Application for Variation of an Environmental Permit

PWP ITEM NO. 6461TH
CENTRAL KOWLOON ROUTE – MAIN WORKS

**Supporting Document for Application of
Variation of Environmental Permit No. EP-457/2013/C**

drawing no.	scale
Diagram 3	1:2000

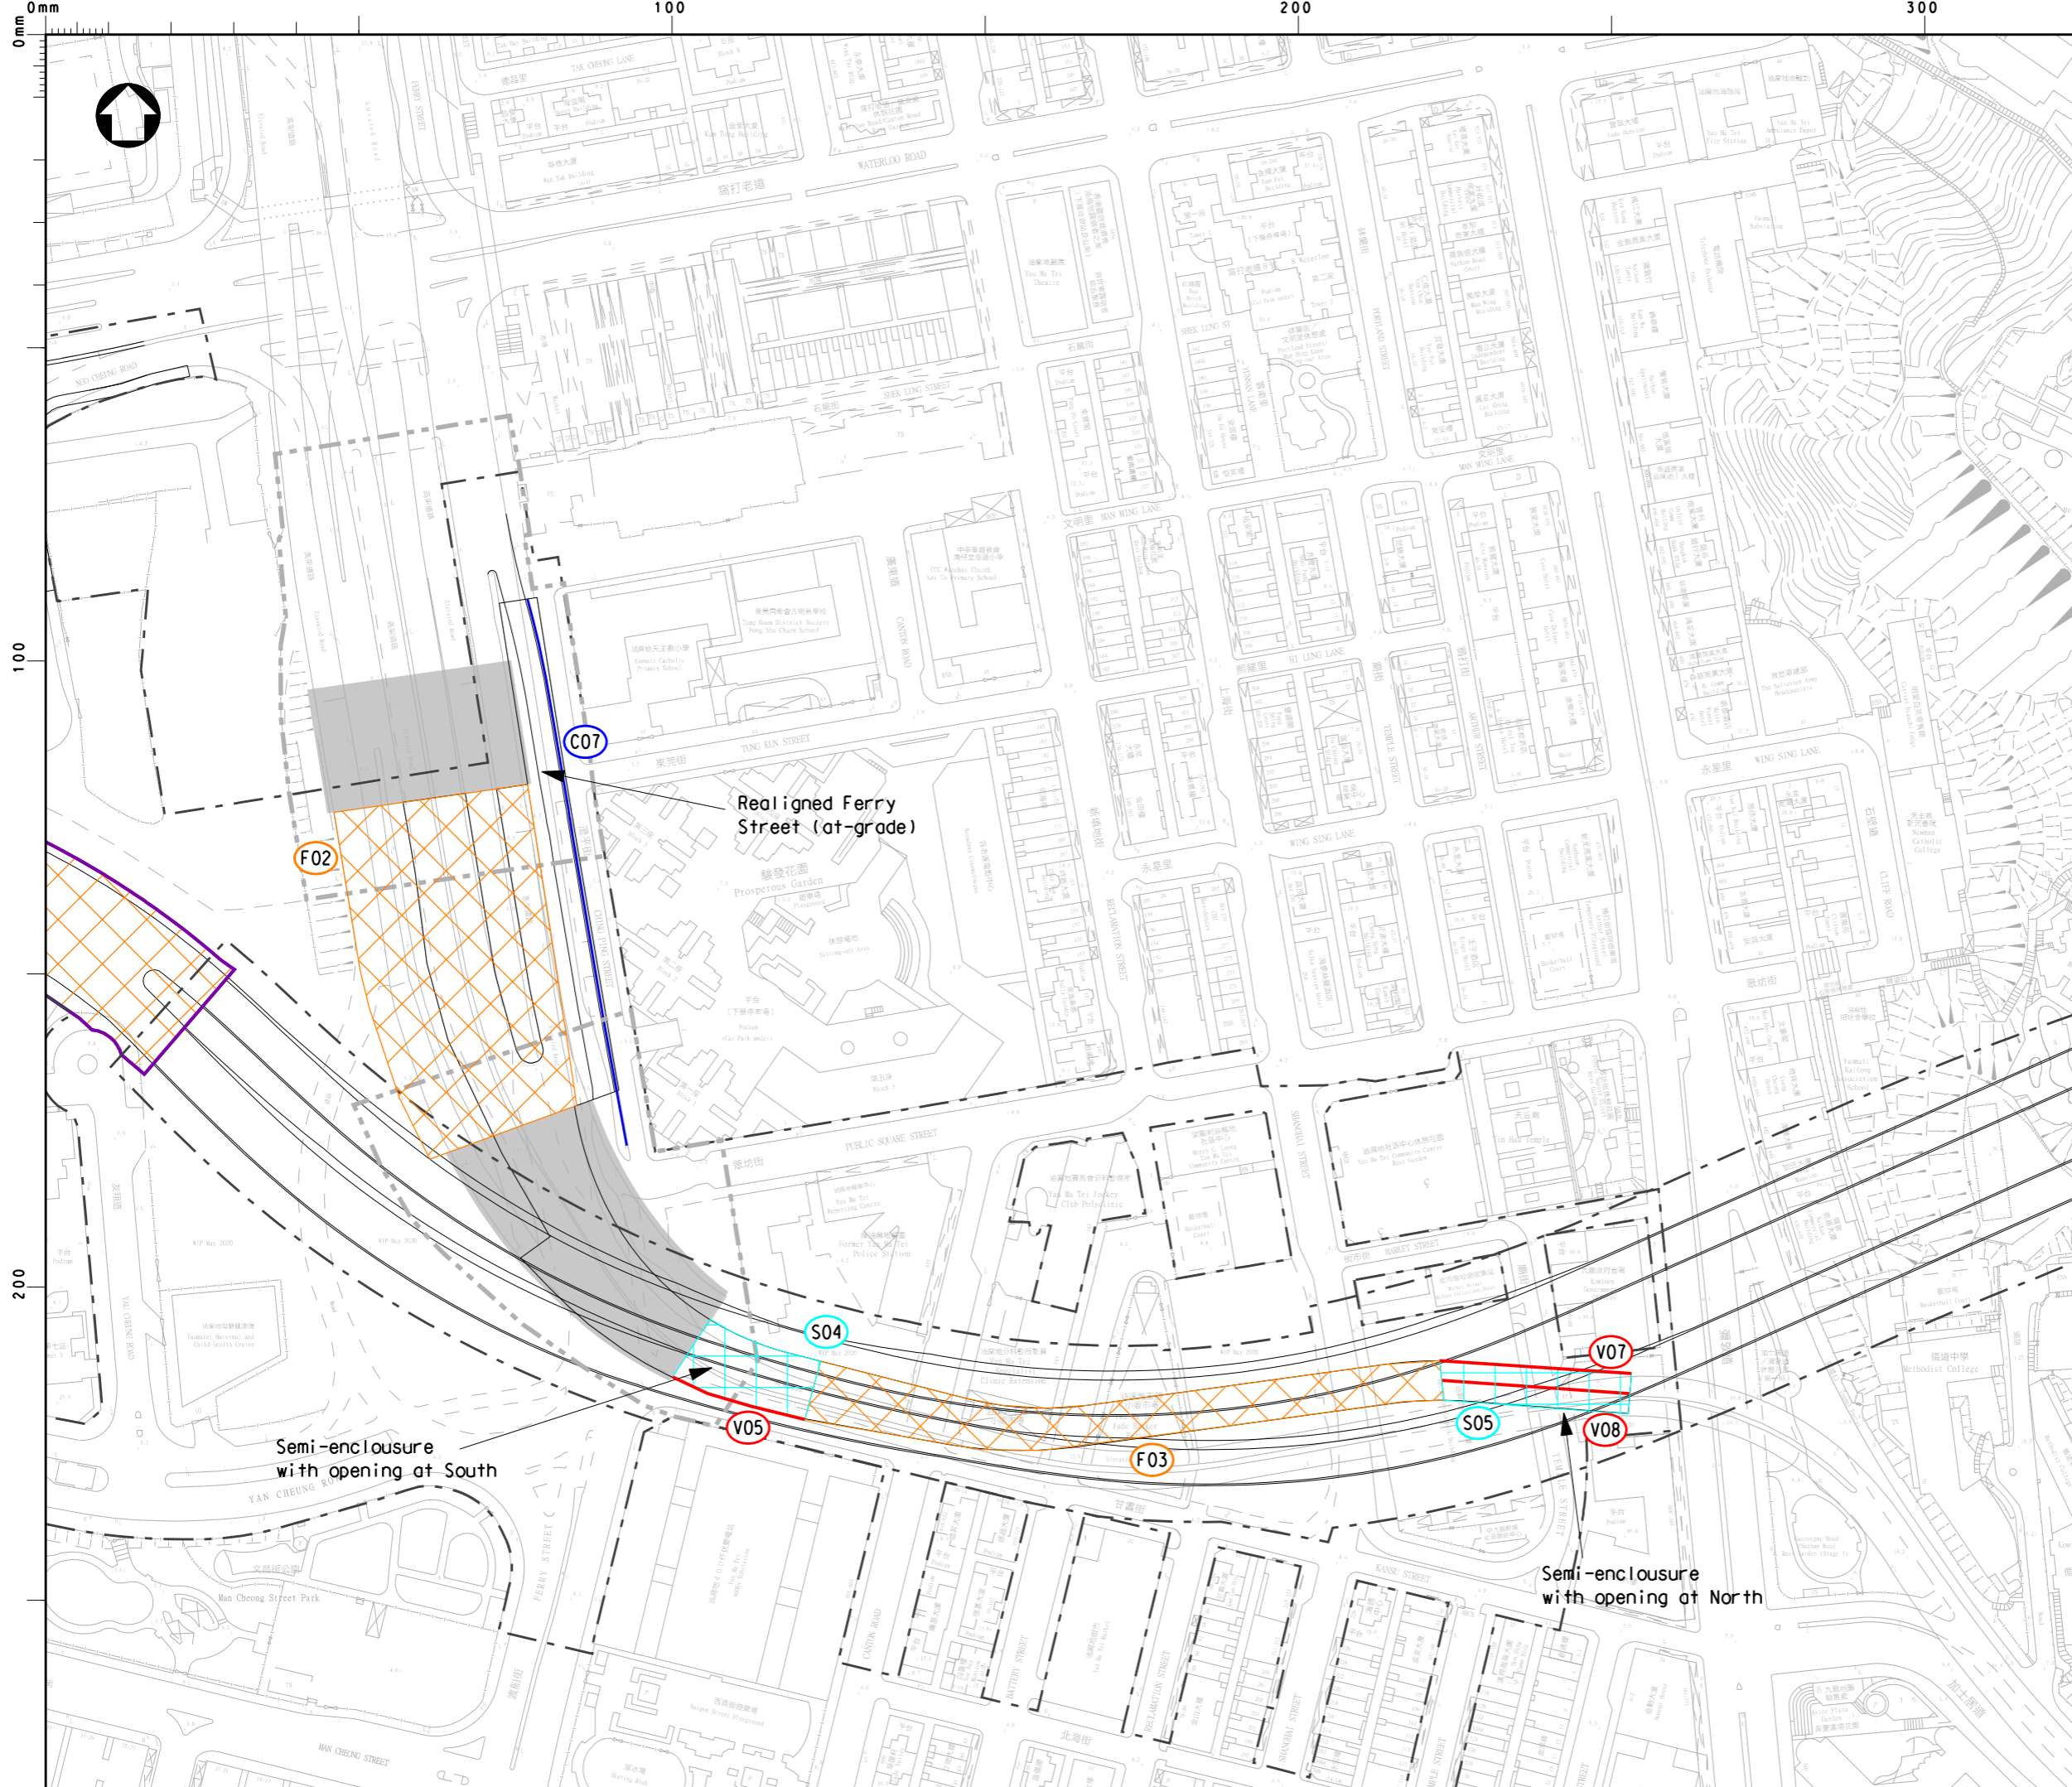
3.1.8 Accordingly, Figure 5c of the current EP will also be amended to reflect these changes. Please refer to Diagram 2 highlighting the proposed amendments (with remarks) and Diagram 3 showing the amended Figure 5c to be adopted in the revised EP.
